**Meridian Airport Authority, Dean Aircraft Services
Hangar Additions & Alterations**

ADDENDUM NO. 4

TO: All Bidders on the Above Referenced Product
FROM: Davis Purdy Architects, PLLC
DATE: March 17, 2020
SUBJECT: **ADDENDUM NO. 4**

E-103

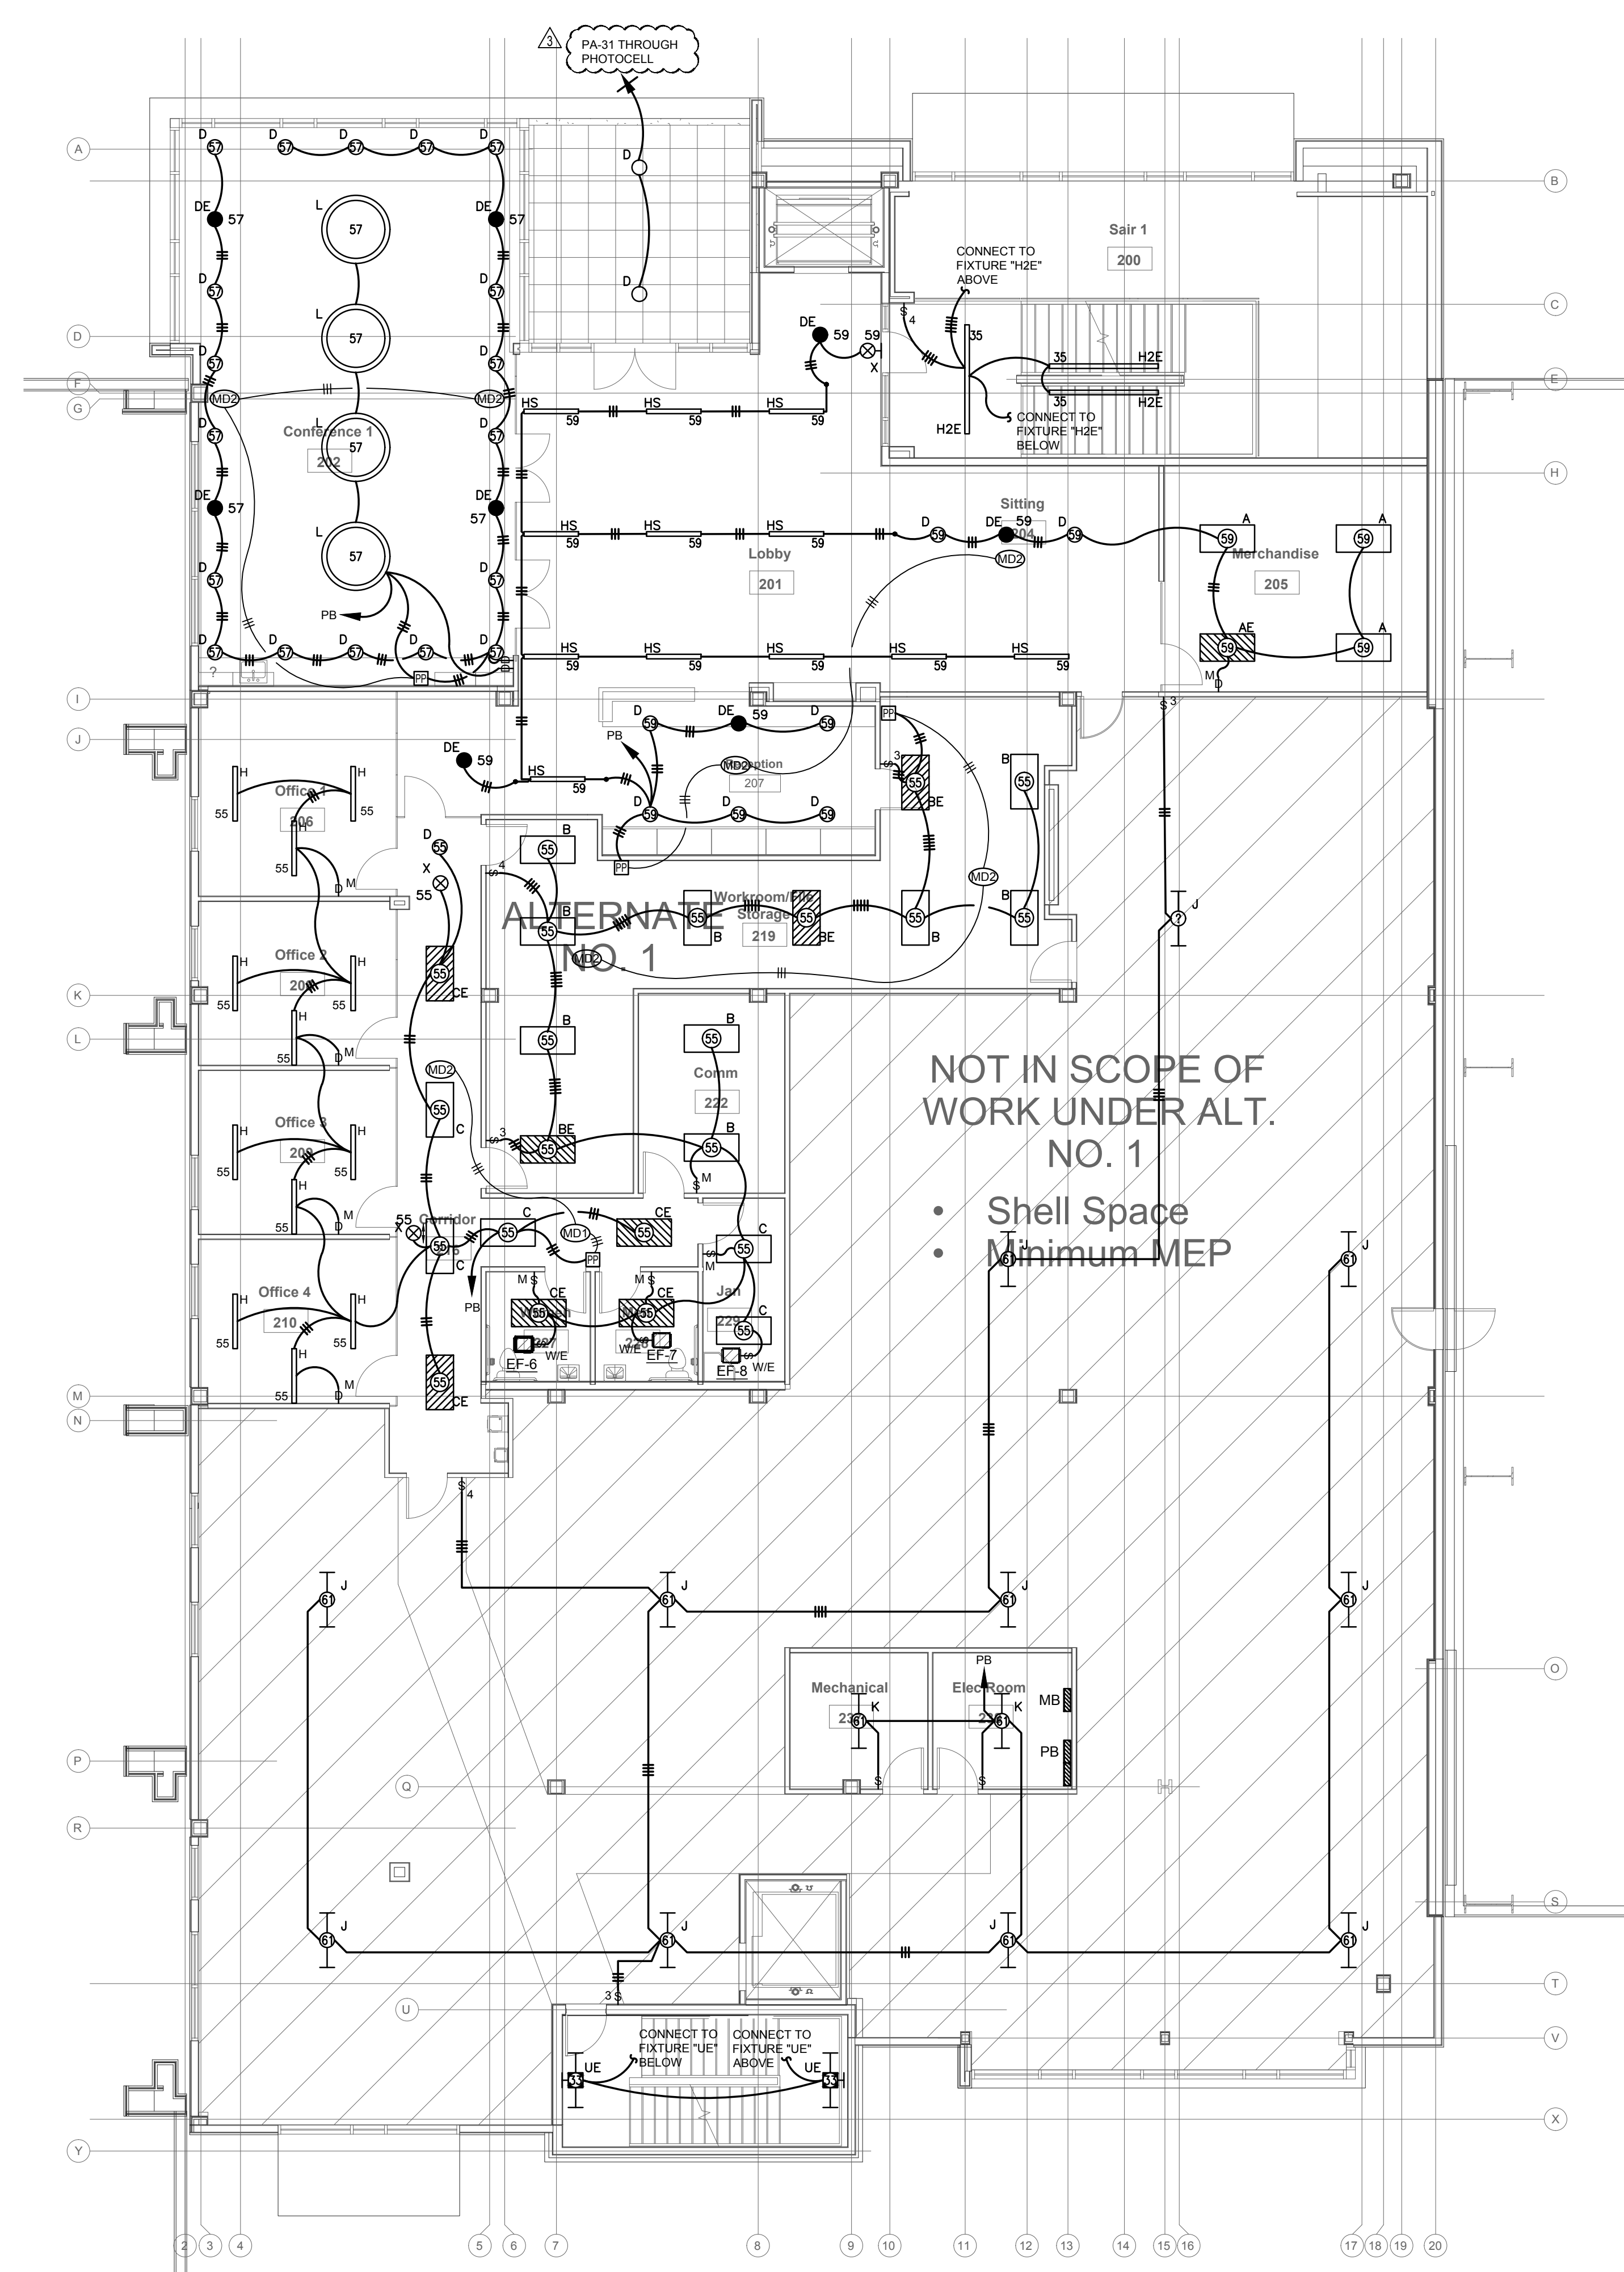
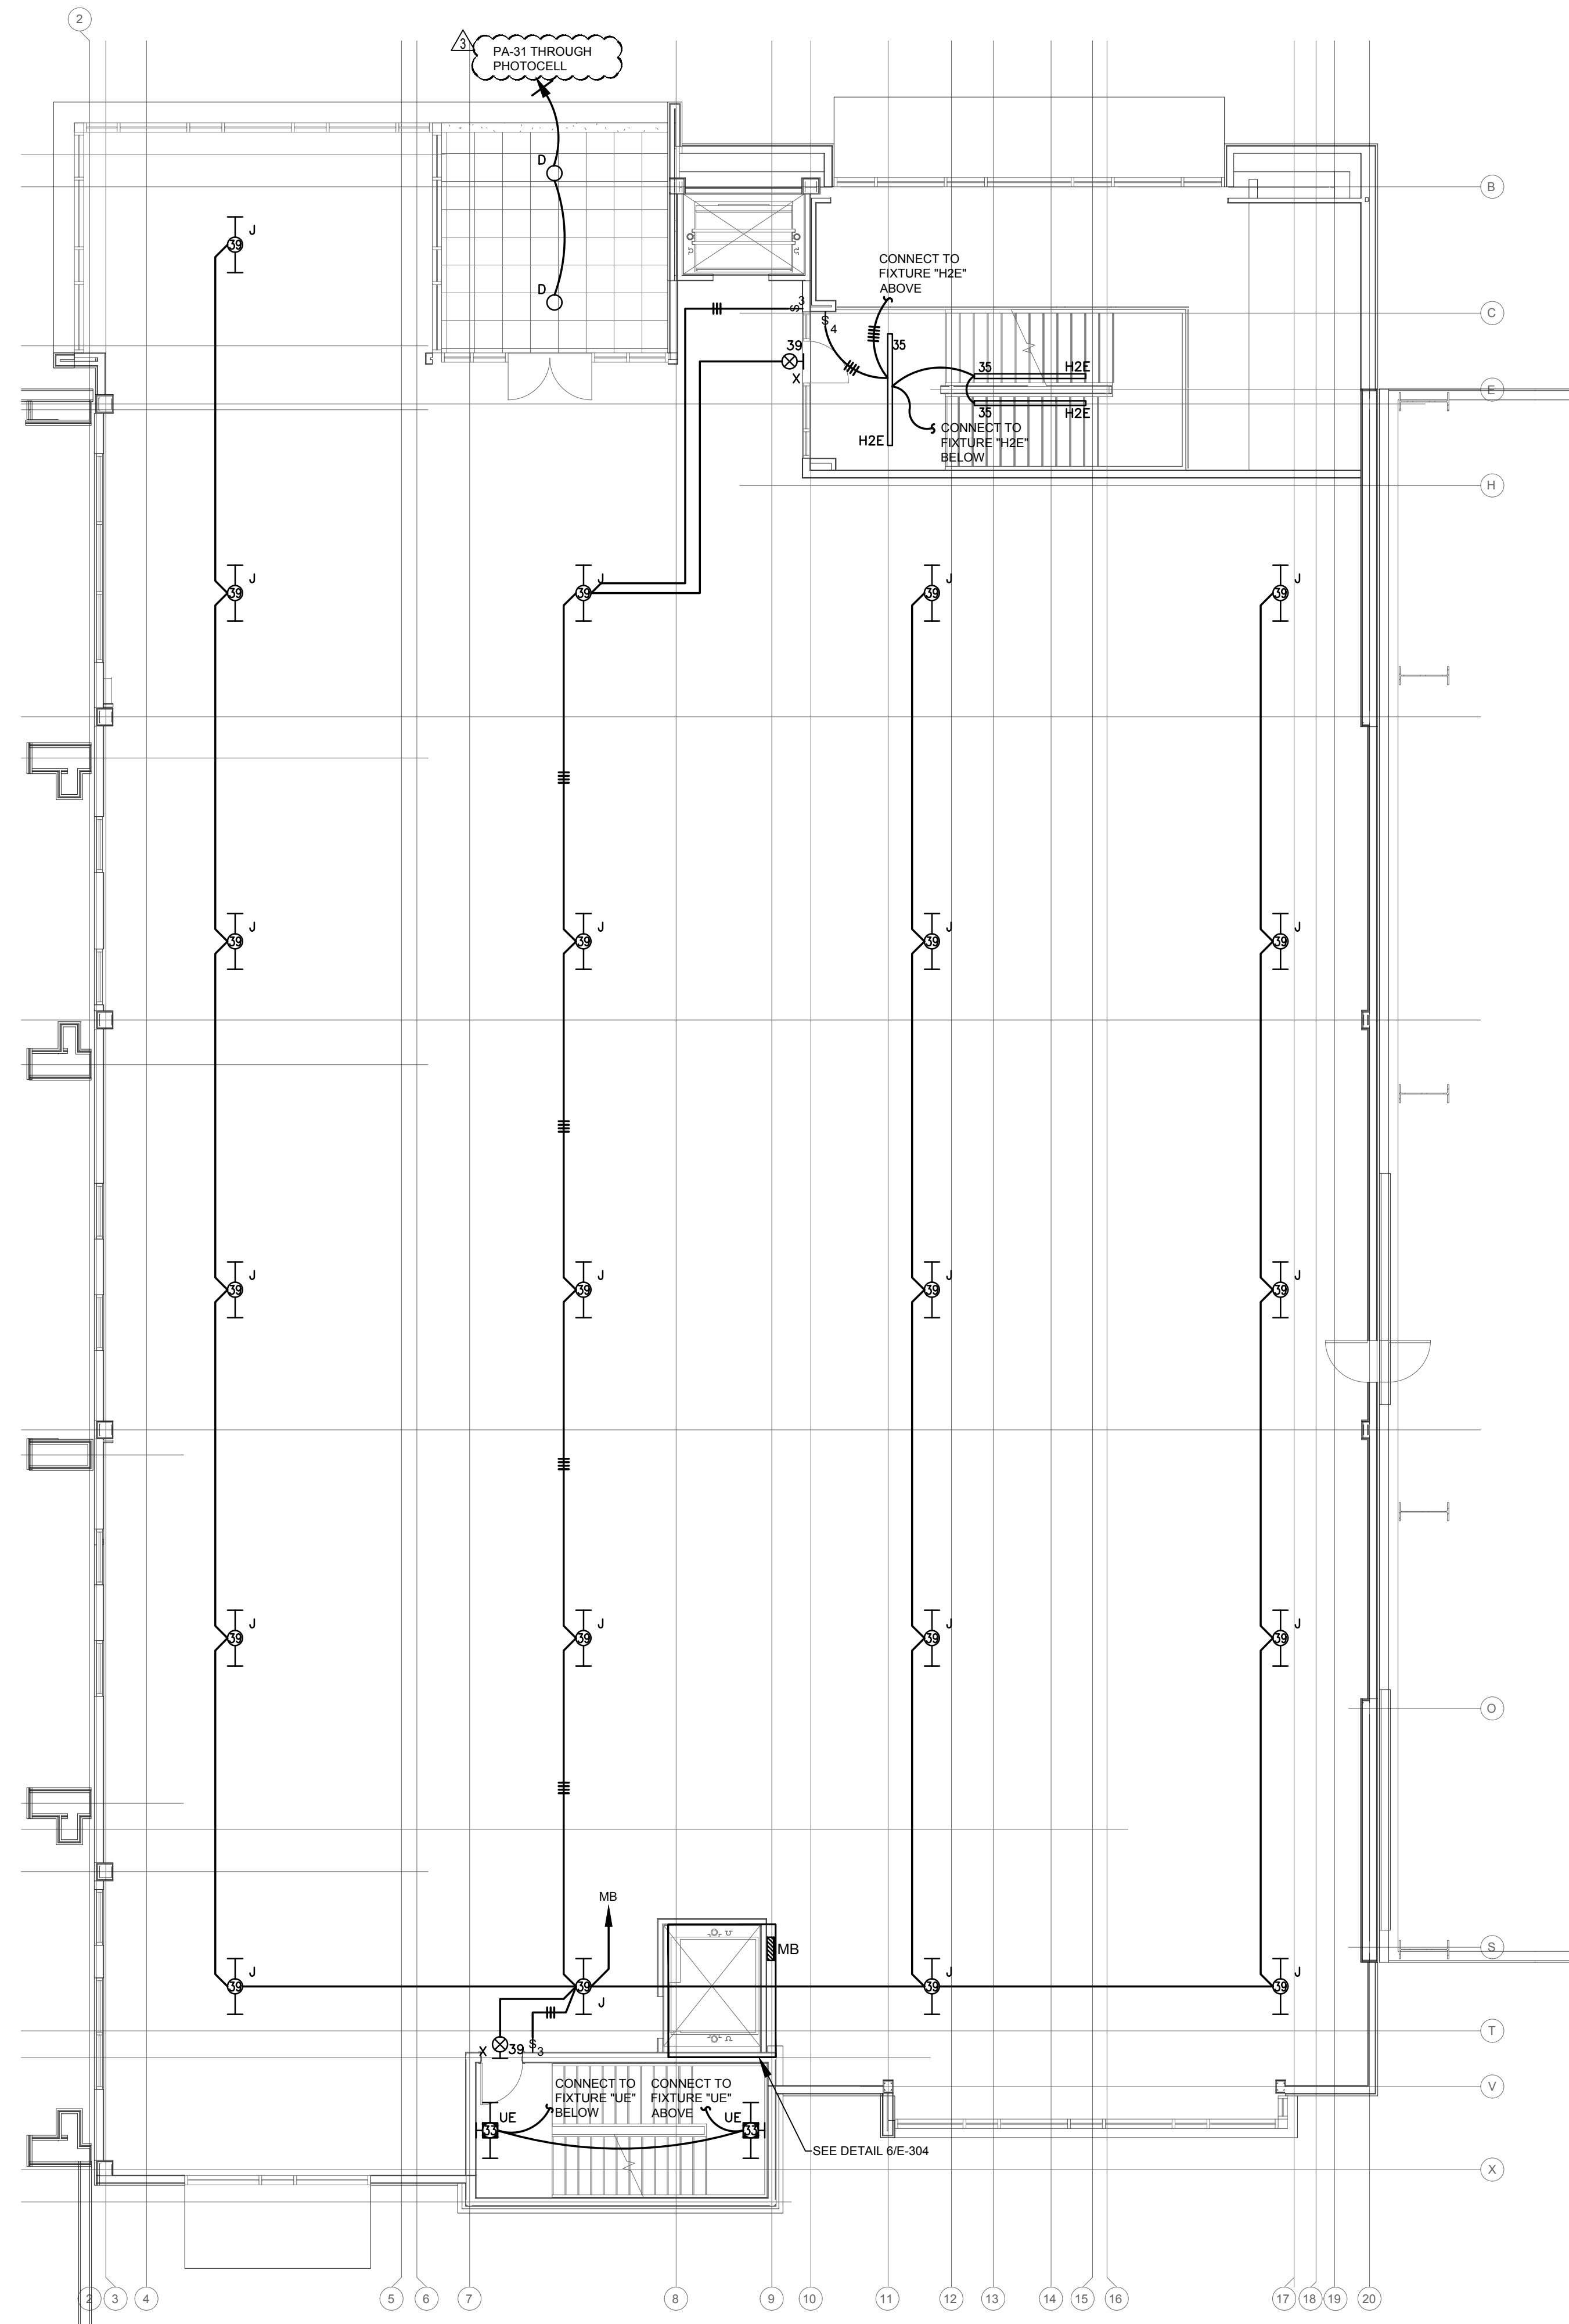
- e. E-103 PARTIAL LIGHTING PLAN 2ND FLOOR PART D**
 - i. Modified exterior fixtures controls.
 - f. E-104 PARTIAL LIGHTING PLAN 2ND & 3RD FLOOR**
 - i. Modified exterior fixtures controls.
